February 20, 2008  
NRC:08:013

**U.S. EPR Final Safety Analysis Report, Supplement 2**

### DESCRIPTION OF CHANGES

Figure 6.2.1-30—LOCA Integrated Break Mass Flow vs. Time (CLPS Break, Long-Term)

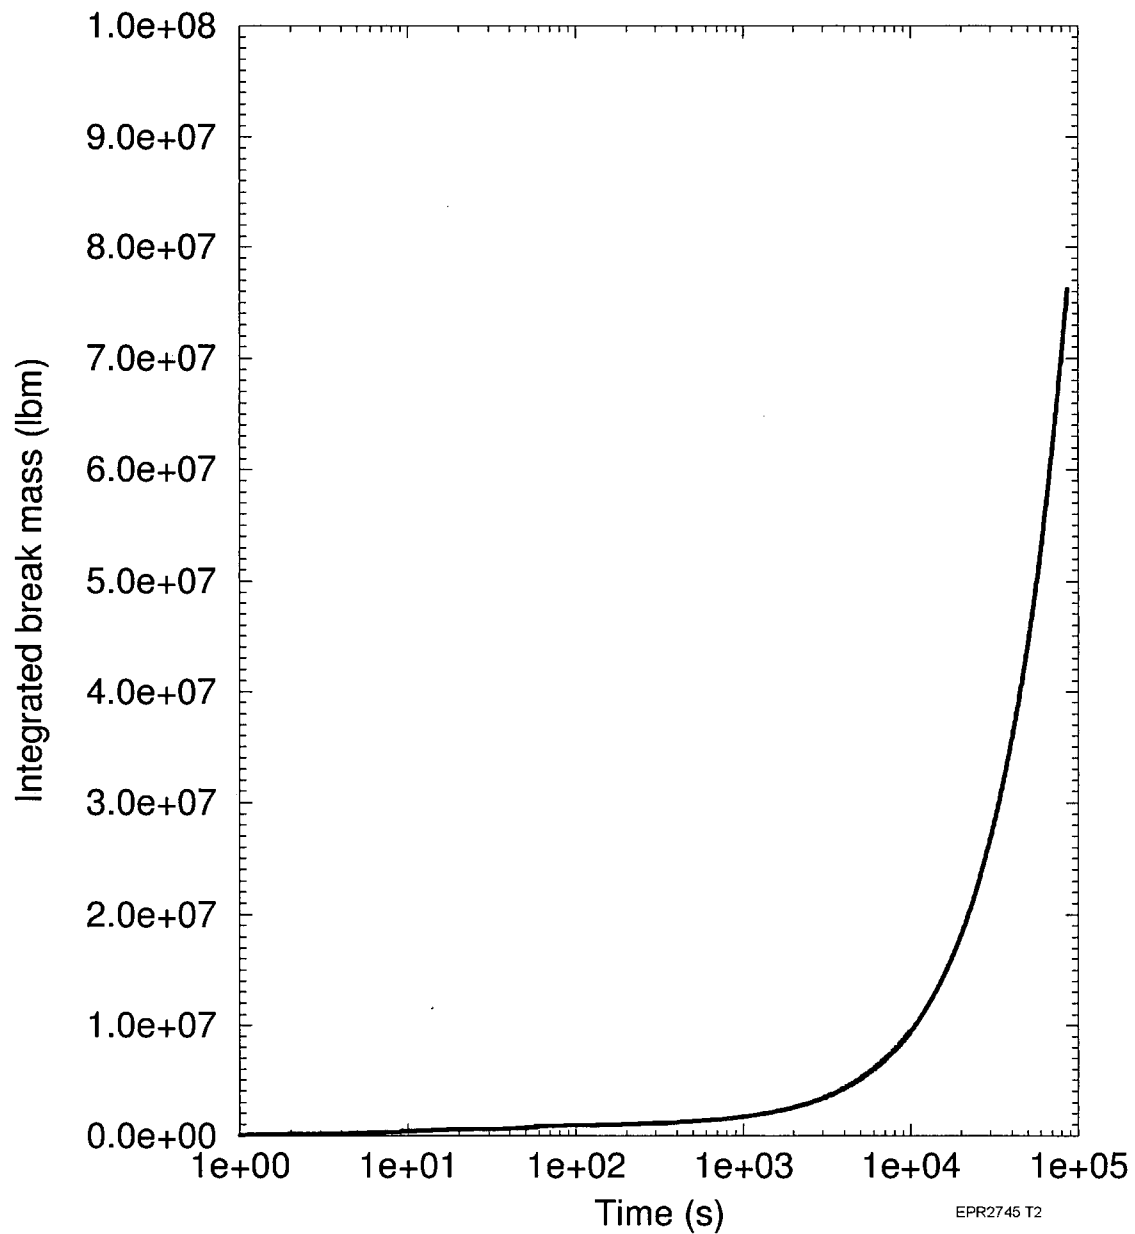
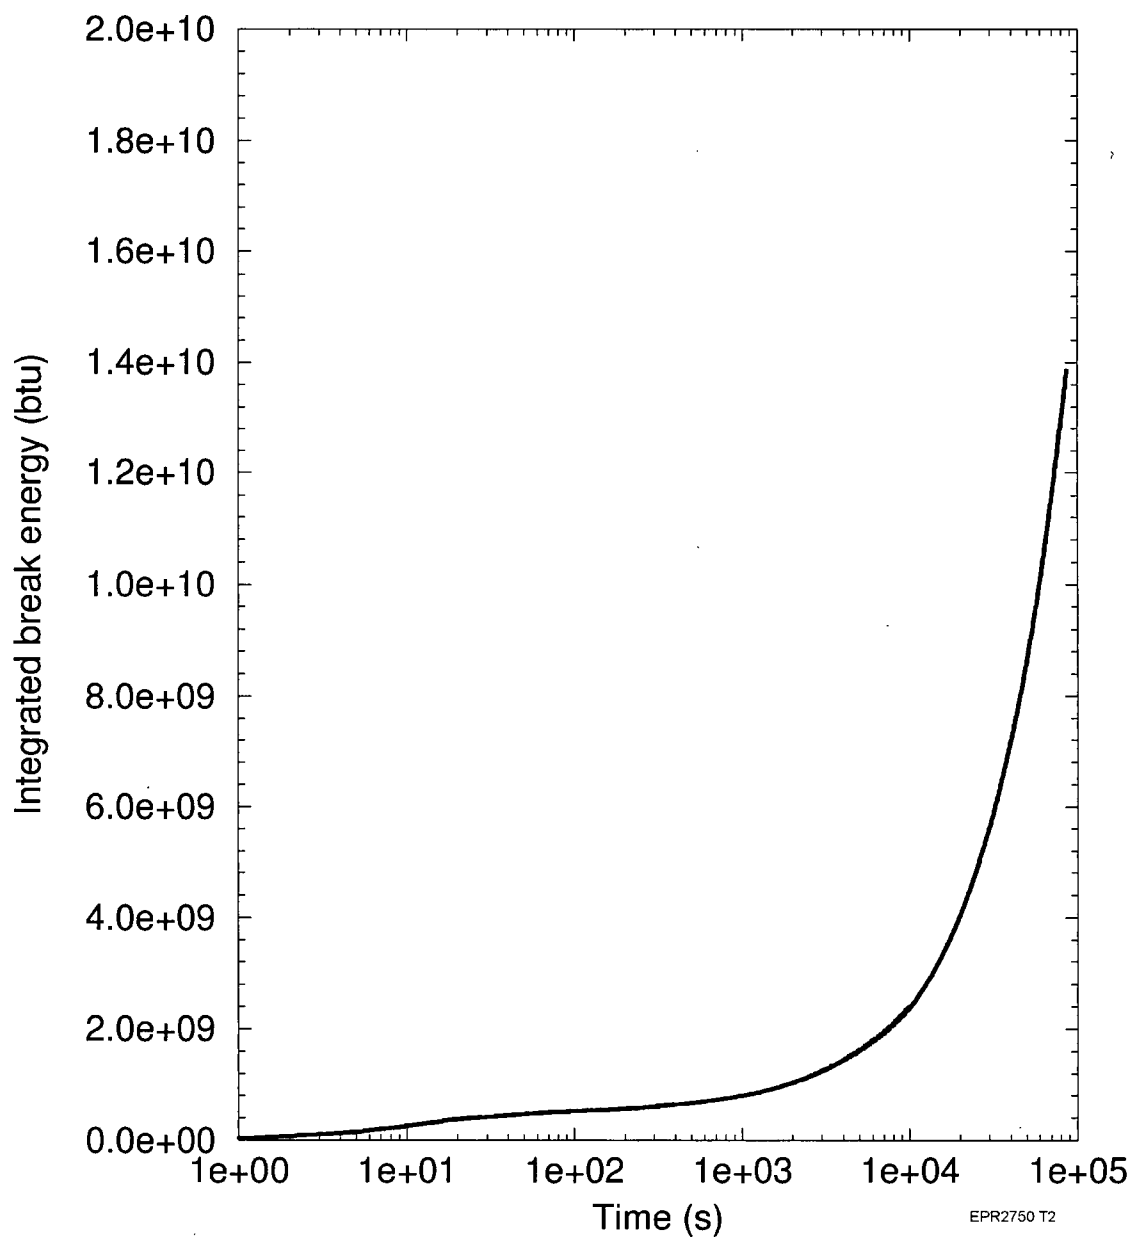
<b>Item</b>	<b>Tier</b>	<b>Section</b>	<b>Changed Pages</b>	<b>Description of Changes</b>
12	2	Tables 6.2.1-18, 6.2.1-19, and 6.2.1-20	6.2-68 – 6.2-99	Revised mass and energy release tables to extend the time duration.
13	2	6.2.1; Tables 6.2.1-23, 6.2.1-24, and 6.2.1-25	6.2-19, 6.2-107 – 6.2-115	1) Added energy inventory tables 2) Revised Section numbering.
14	2	Figures 6.2.1-16, 6.2.1-17, 6.2.1-30, 6.2.1-31	6.2-117, 6.2-118, 6.2-131, and 6.2-132	Replaced figures to reflect results of revised calculations which corrected modeling error of safety injection.

Figure 9.4.1-3—Control Room Envelope Air Supply and Recirculation Subsystem

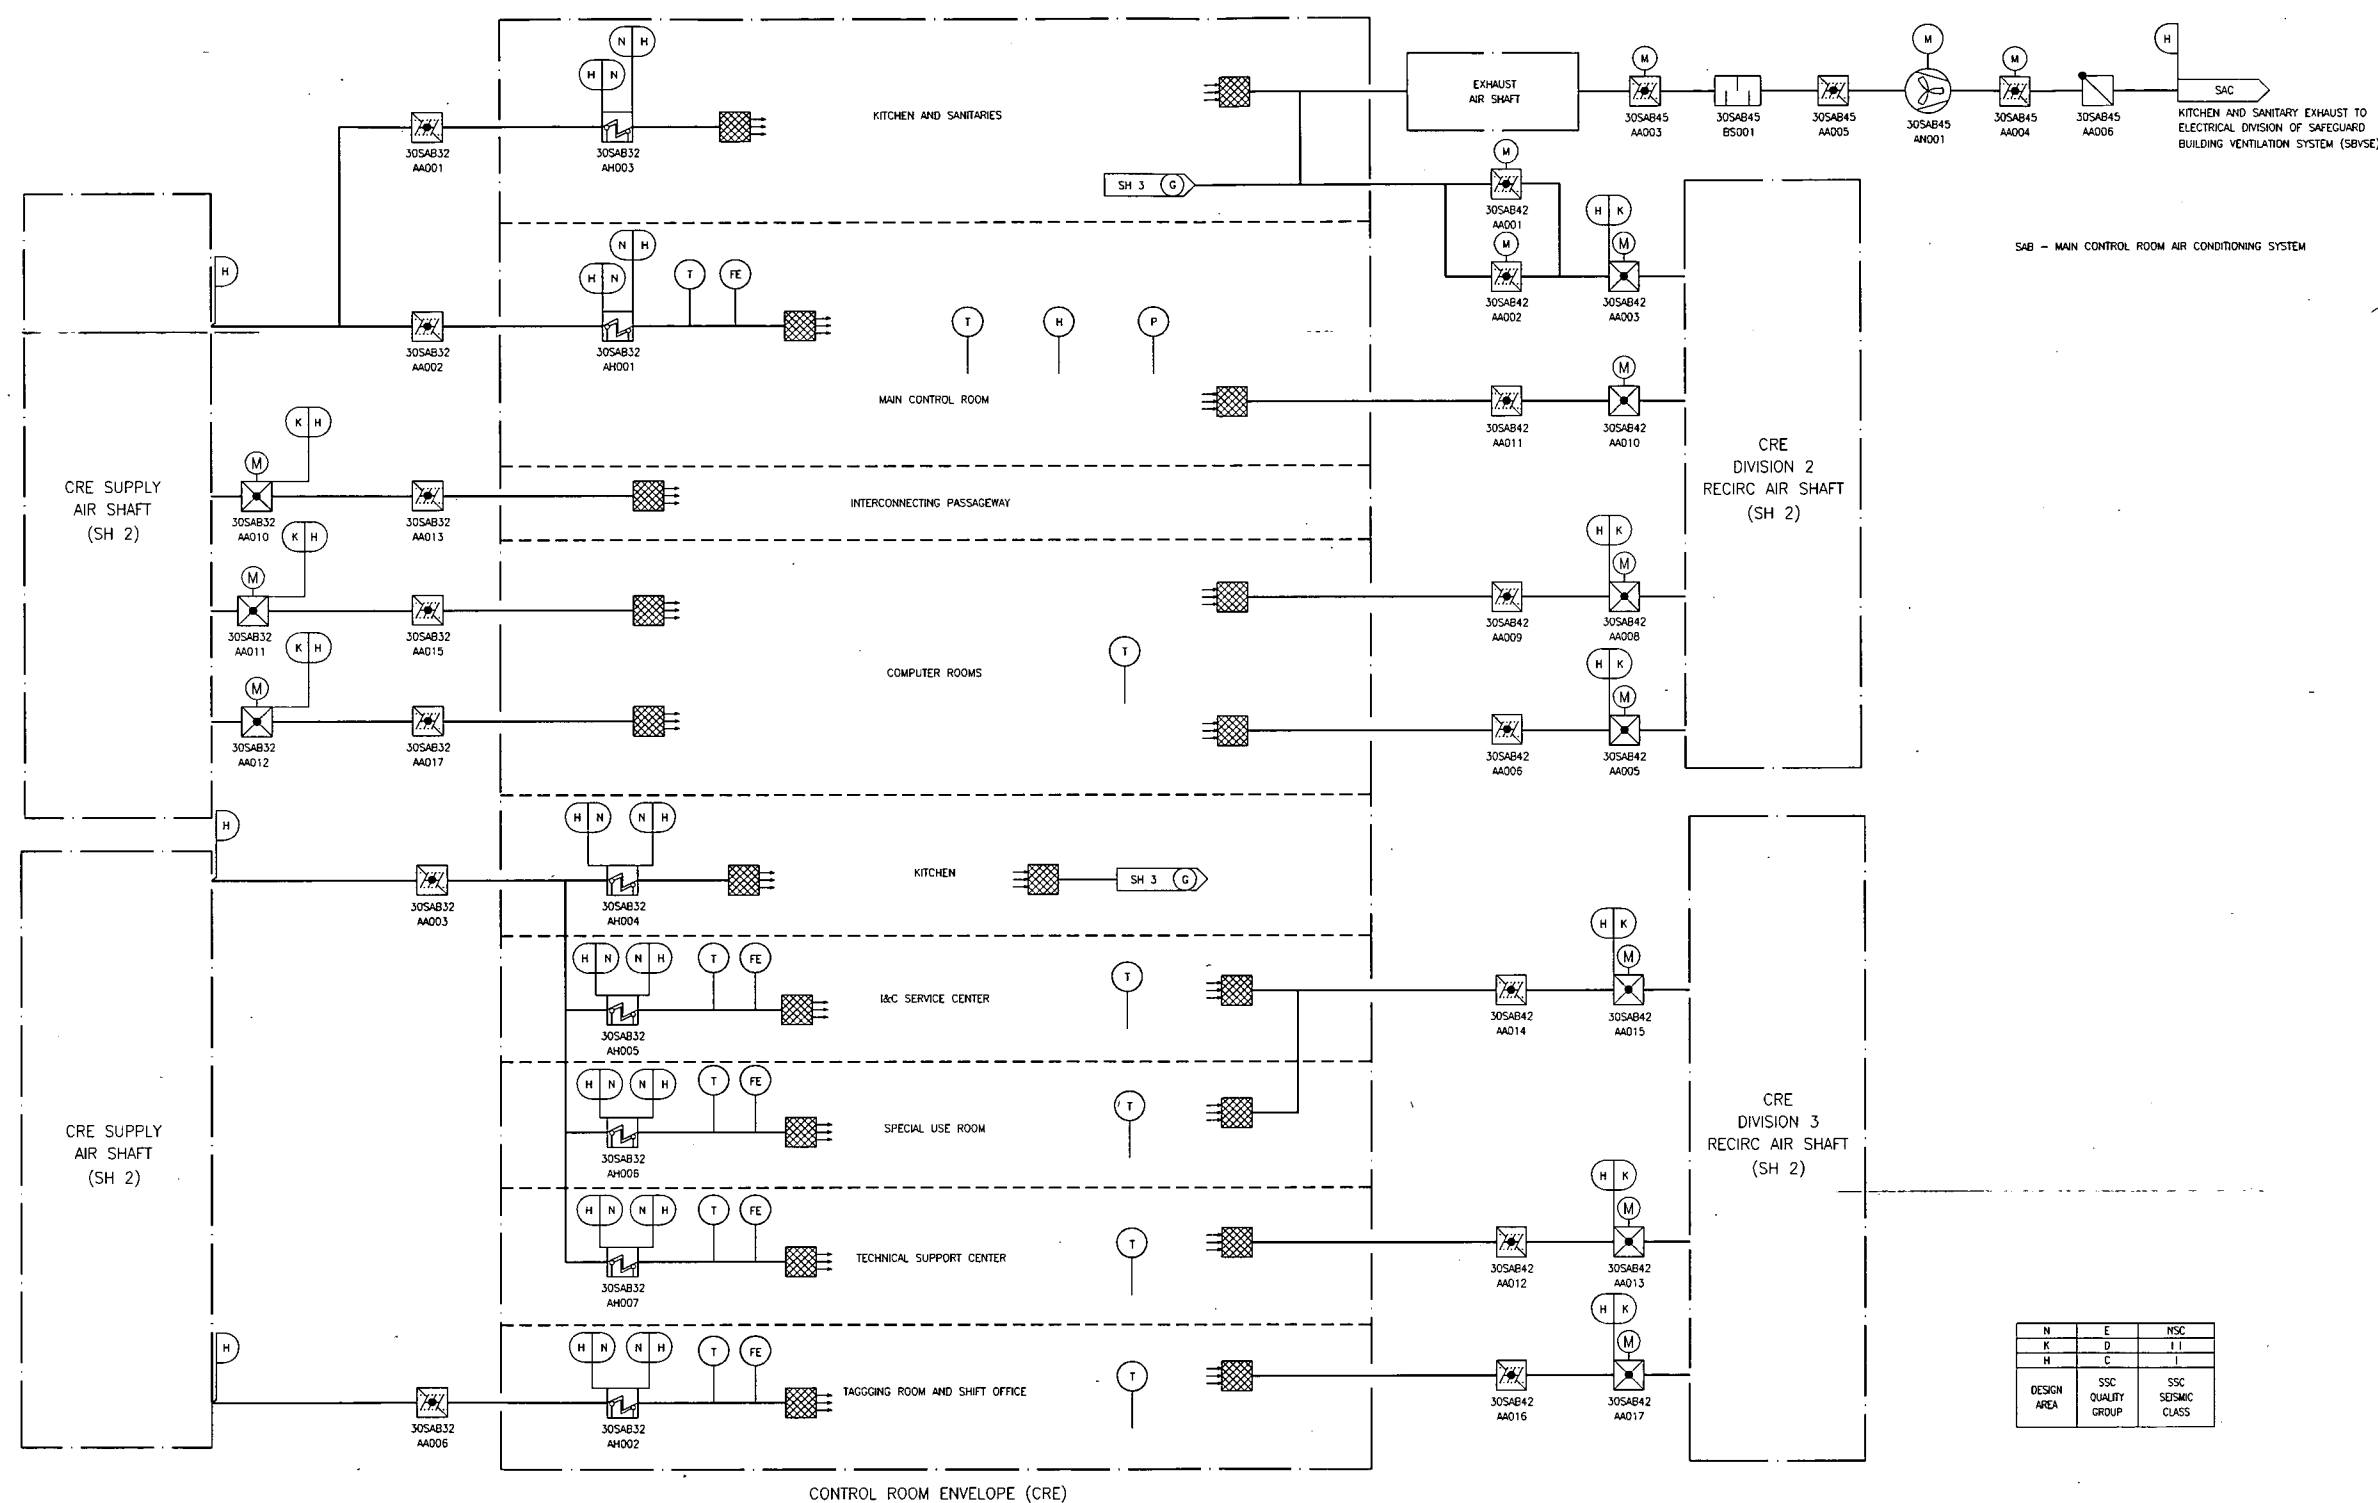
8	2	1.8 6.4	1.8-2, 1.8-4 6.4-1 – 6.4-7	1) Delineated parts of MCR habitability system related to toxic gas as conceptual. 2) Added toxic gas detectors for MCR as an interface item for Table 1.8-1.
9	2	9.4.1	9.4-2, 9.4-3, 9.4-7, 9.4-9, 9.4-13	Delineated parts of MCR HVAC description related to toxic gas as conceptual.
10	2	Ch 16 TS 3.7.10 TS 5.5.17 B 3.7.10 B 3.7.12	3.7.10-1 5.5-14 – 5.5-15 B3.7.10-1 – B3.7.10-8 B3.7.12-4	Delineated information related to toxic gas in technical specifications and bases as conceptual
11	2	Table 1.8-2	1.8-33	1) Added COL item identified in text of Chapter 10 to provide a list of material specifications for the alternate turbine-generator components if an alternate turbine is selected. 2) Section reference for COL item 10.2-2 and editorial text change of "data from" to "properties of."

[[TG-Toxic Gas Sensors]]
